PCN-20190104 TE0703-05 to TE0703-06 Hardware Revision Change

| PCN Number | PCN-20190104 |
| Title | TE0703-05 to TE0703-06 Hardware Revision Change |

This change affects all variations of TE0703 carrier of revision: TE0703-05

#8 Routing lenght of differential pairs B34_L17, B34_L15, B34_L21, B34_L13, B34_L10, B34_L20 changed

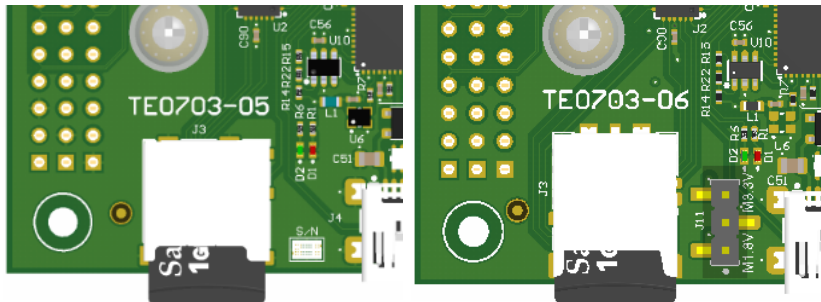
Type: Layout change

Reason: Other changes and limited space on PCB

Impact: Applications with exact timing requirements on these IOs have to be checked and if necessary adjusted
